Technical product information

Transaction No.: 2032874/1

Continental Series - W12 Engine - Bank 2 Deflection pulley noisy

Figure 1

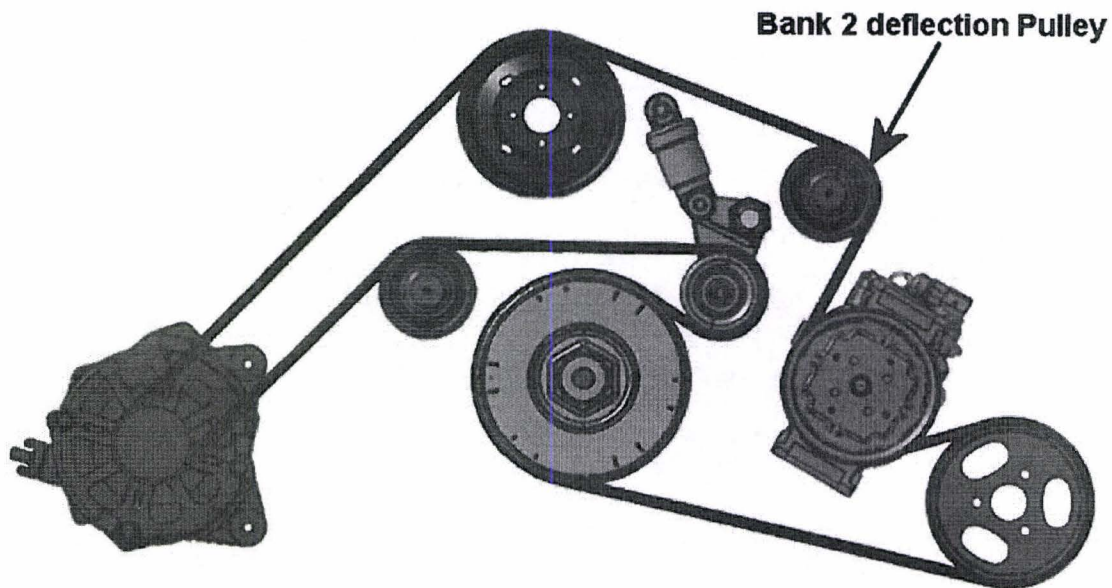
In the event that the Bank 2 accessory drive belt deflection pulley (Figure 1) is diagnosed as unserviceable/noisy leading to the pulley requiring replacement, please commence with this TPI.

Figure 2

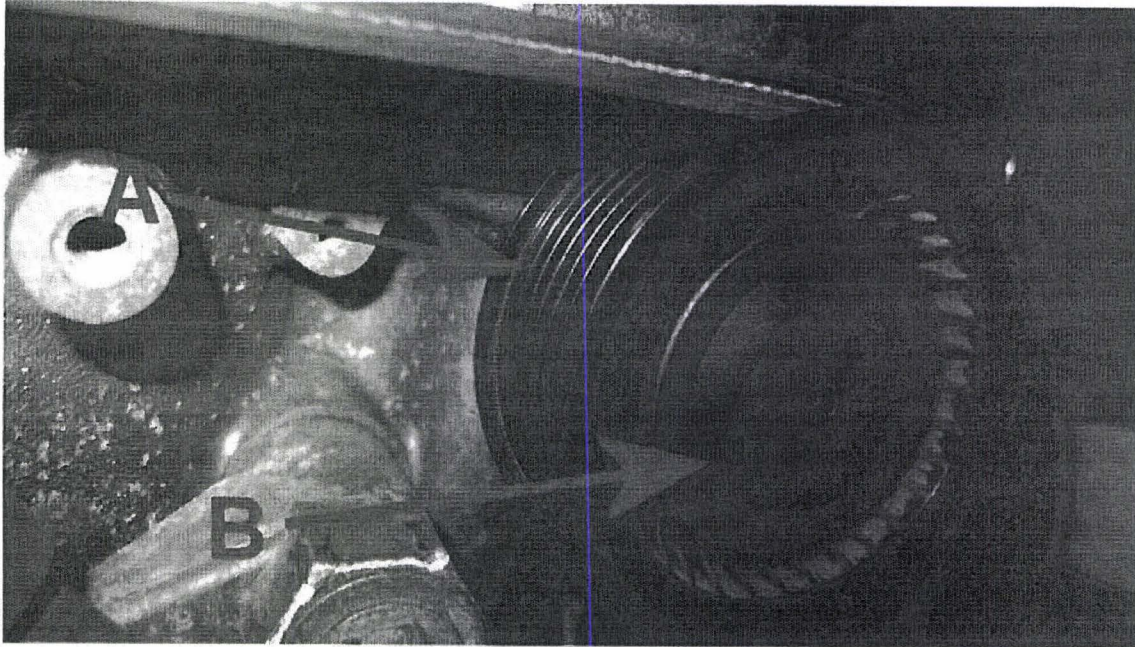
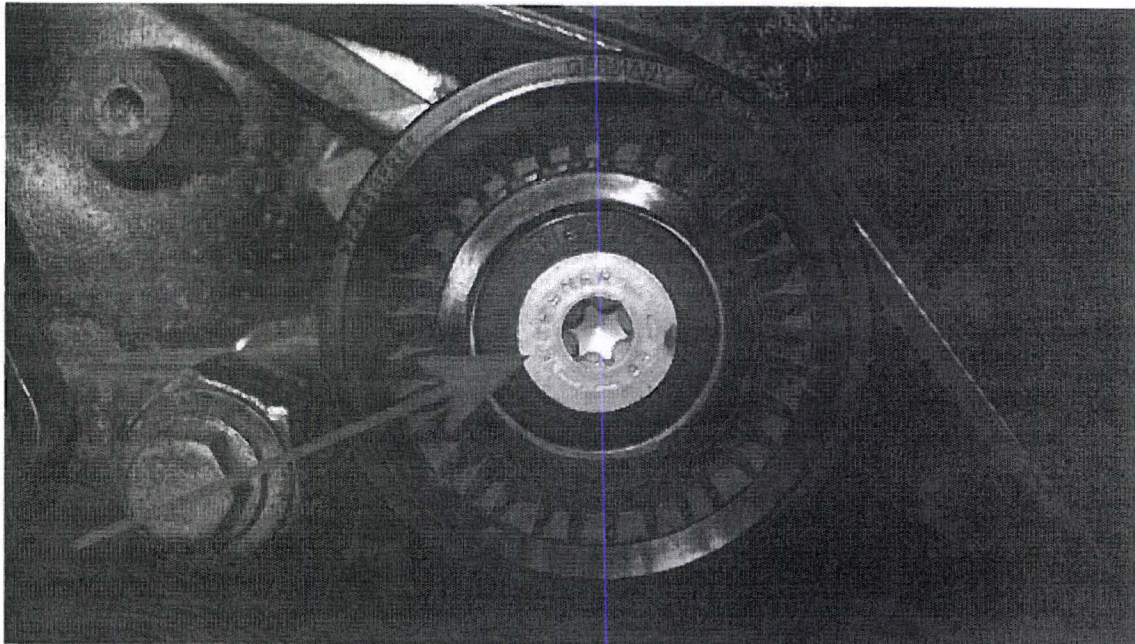
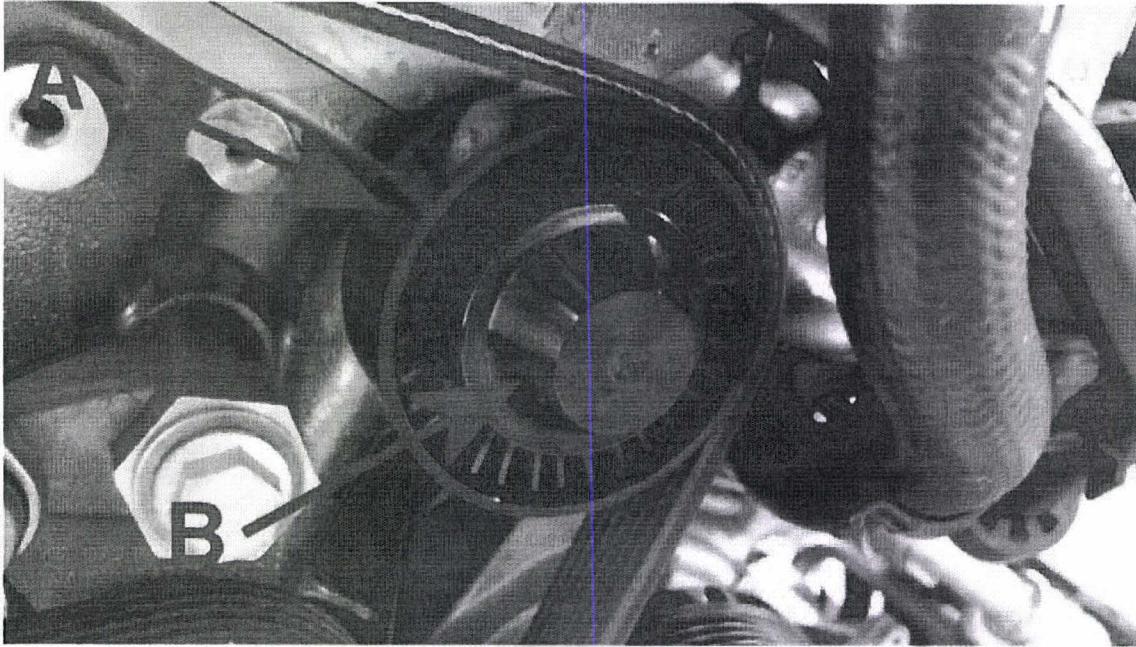
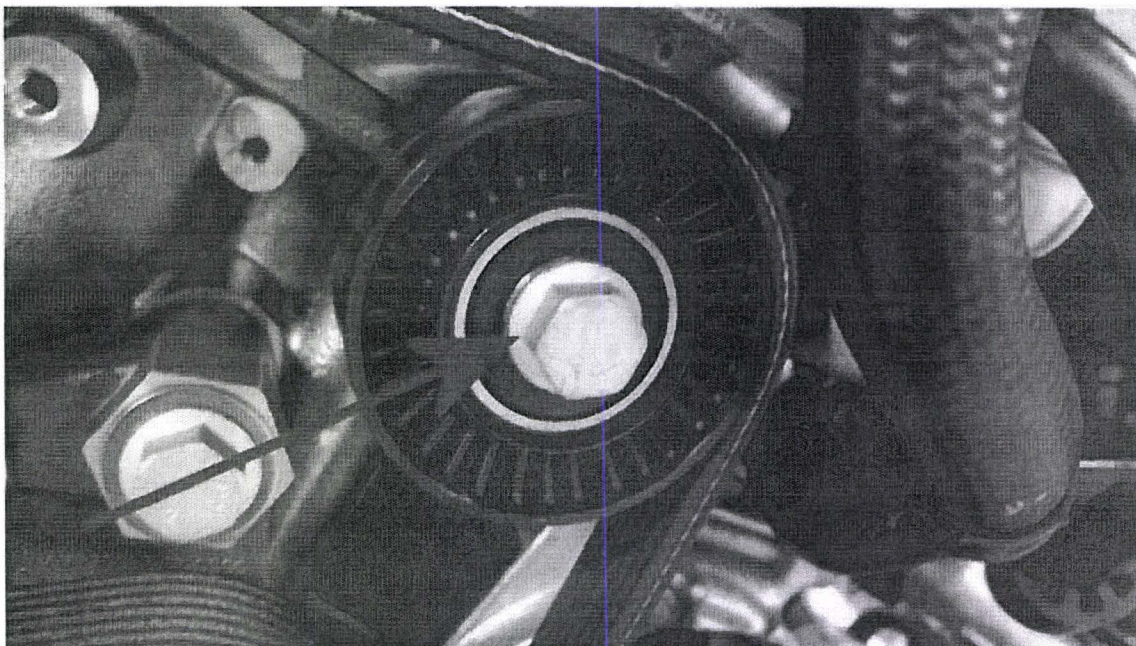
A new specification Bank 2 deflection pulley is now available, there are a number of significant changes which have been introduced, they are as follows:

- The original pulley operated using a single row ball bearing
- The original specification single row pulley can be identified as it has a grooved belt running surface (Figure 2 point A) and also a shallow cone shaped dust cap (Figure 2 point B)
- The original pulley is secured with a Torx bolt as shown in Figure 3

- The latest specification part now operates using a double row ball bearing
- The pulley can be identified as is has a smooth belt running surface (Figure 4 point A) and a deep cone shaped dust cap (Figure 4 point B)

-The new specification pulley is now supplied and secured with a 16mm Hexagon headed bolt (Figure 5) Do not under any circumstances use any other fixing other than the new 16 mm Hexagon headed bolt supplied with the latest specification pulley

Do Not ever attempt to fit the latest specification pulley with the part number 07C 145 276F to Bank 1, this pulley must only ever be fitted to Bank 2

Figure 6

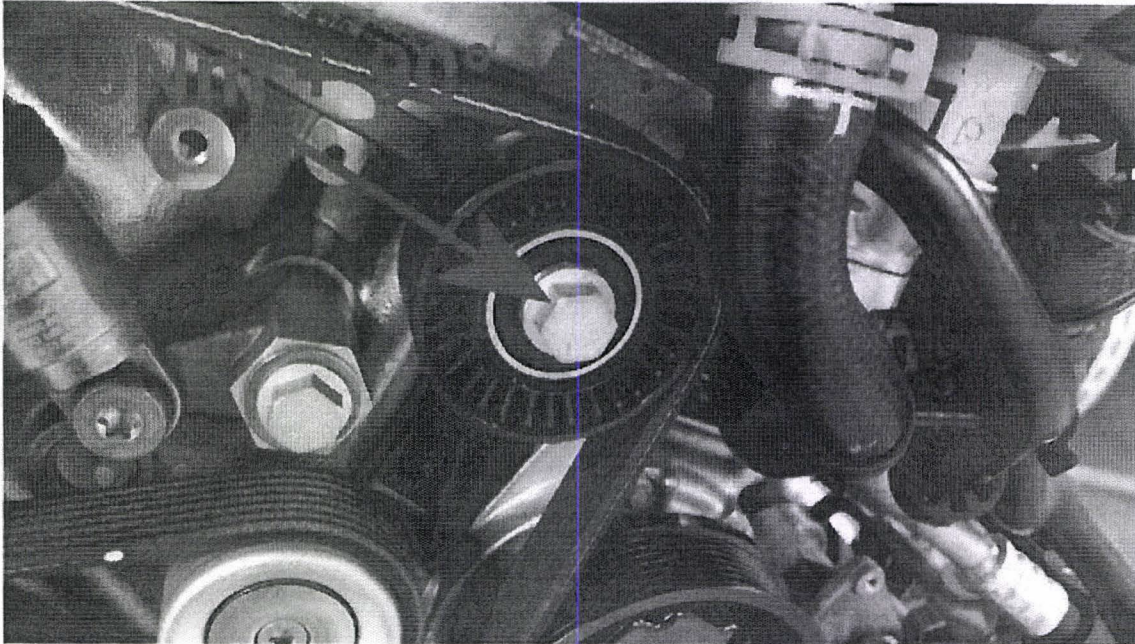
Replace the Bank 2 accessory drive belt deflection pulley - Refer to Workshop Manual Rep.Gr 13 - Accessory Drive Belt Deflection Pulley - Bank 2 - To Replace **NOTE:** The torque for the latest specification deflection pulley fixing (Figure 6) is 40 Nm + 90 degrees and refit the dust cap
